**TOWN OF NEWBURGH  
PLANNING BOARD  
TECHNICAL REVIEW COMMENTS**

**PROJECT NAME:** 273 ROUTE 17K CHANGE OF USE-RESTAURANT  
**PROJECT NO.:** 23-05  
**PROJECT LOCATION:** 273 ROUTE 17K  
SECTION 90, BLOCK 6, LOT 1  
**REVIEW DATE:** 15 SEPTEMBER 2023  
**MEETING DATE:** 21 SEPTEMBER 2023  
**PROJECT REPRESENTATIVE:** A. HENNESSY ARCHITECTS

**TOWN OF NEWBURGH  
PLANNING BOARD  
TECHNICAL REVIEW COMMENTS**

**PROJECT NAME:** 273 ROUTE 17K CHANGE OF USE-RESTAURANT  
**PROJECT NO.:** 22-05  
**PROJECT LOCATION:** 273 ROUTE 17K  
SECTION 90, BLOCK 6, LOT 1  
**REVIEW DATE:** 31 MARCH 2023  
**MEETING DATE:** 6 APRIL 2023  
**PROJECT REPRESENTATIVE:** A. HENNESSY ARCHITECTS

**5 FENCE DETAIL**  
S1.0 SCALE: 3/4" = 1'-0"

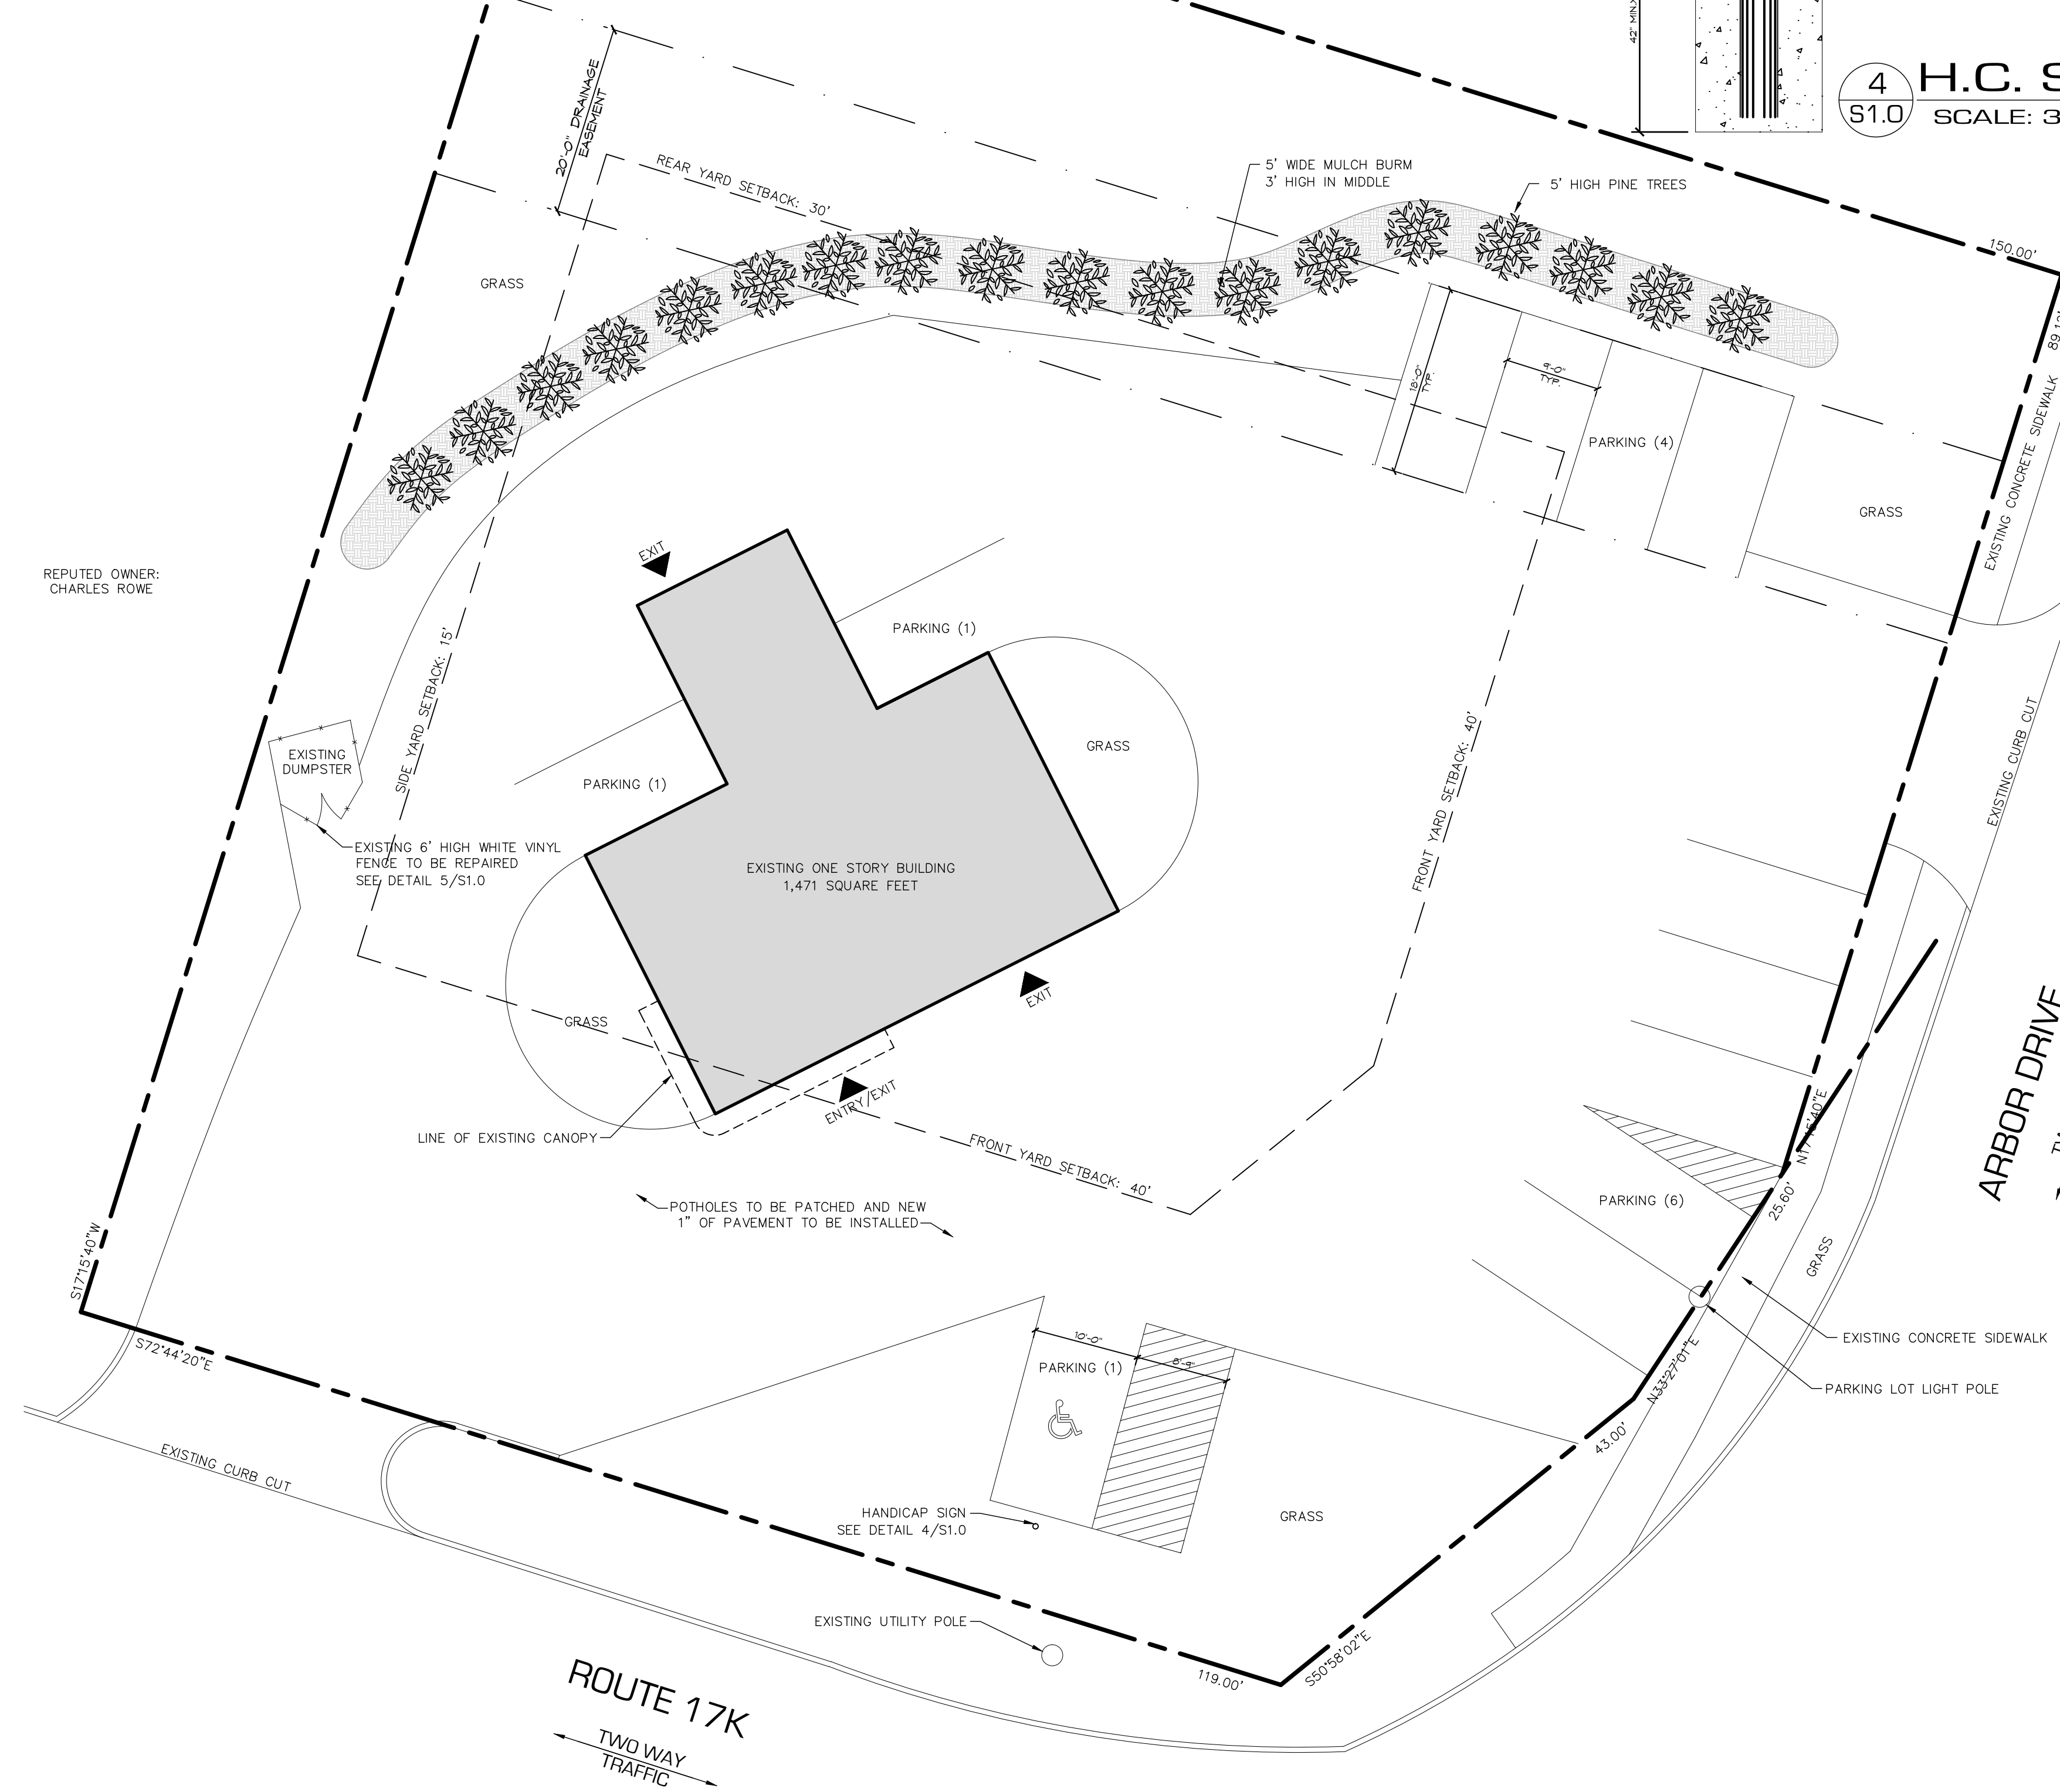
4. At the last meeting a discussion regarding the dumpster enclosure occurred, plans show a detail of this repair.
5. The note has been added to the plans stating that” potholes to be patched and new 1 inch of pavement to be installed”.

**1 PROPOSED SITE LAYOUT**  
S1.0 SCALE: 3/16" = 1'-0"

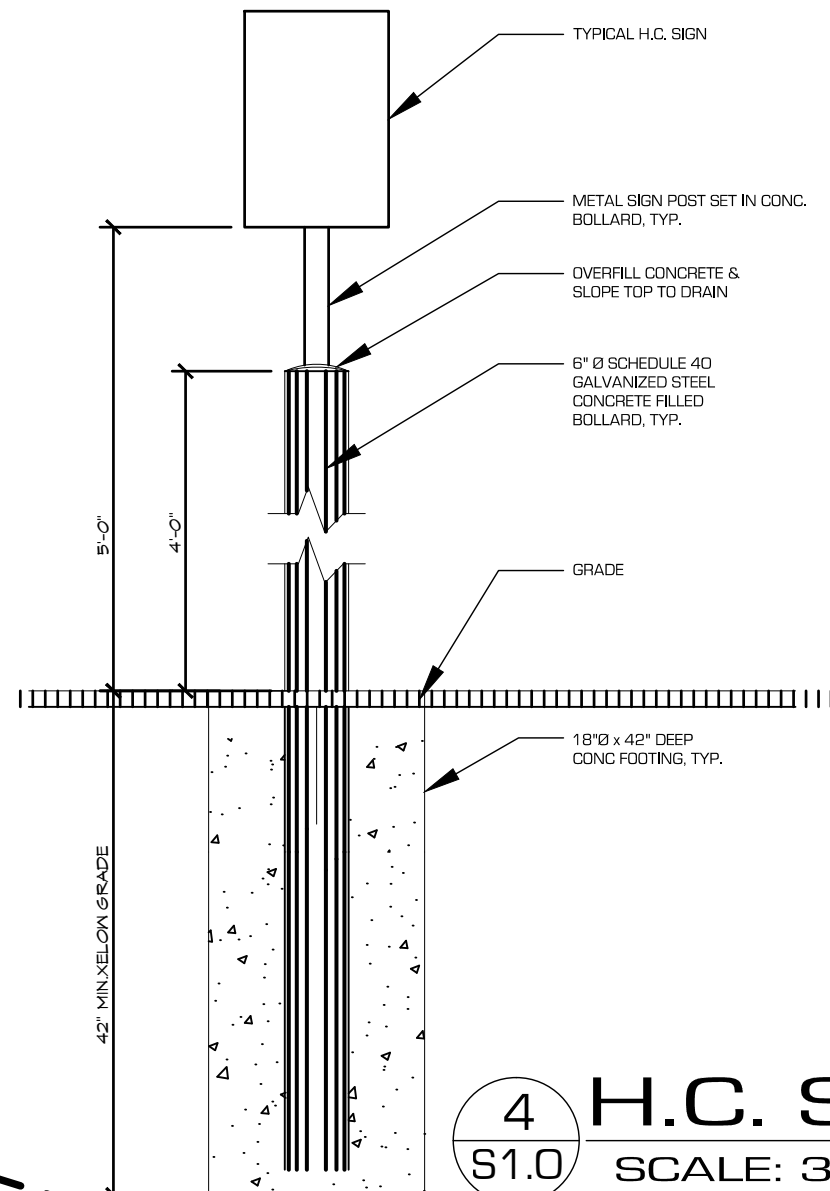
8. The front yard setback from Route 17k continues to be depicted at 40 ft. This setback should be depicted at 60 ft. per Town Code for front yards on State Highways.

3. The project requires a front yard variance for the existing conditions on NYS Route 17K. the applicants have identified a 40 foot front yard setback, while Section 185-18C(4)(b) identifies that front yards abutting all County and State highways shall be at least 60 feet in depth, except when the majority of existing buildings on either side of the road within 300 feet from the intersection of the nearest property line and street line are lesser average depth. In such case the front yard shall be 50 feet or the average of all lot depths within 300 feet, whichever is greater. Since the applicant requires a variance for a front yard setback, the variance request should be for the 60 feet where 35.7 feet is provided. Front yard setback on the plans should be changed to the 60 foot width at the 17K frontage.

9. Size of the existing parking spaces should be dimensioned.
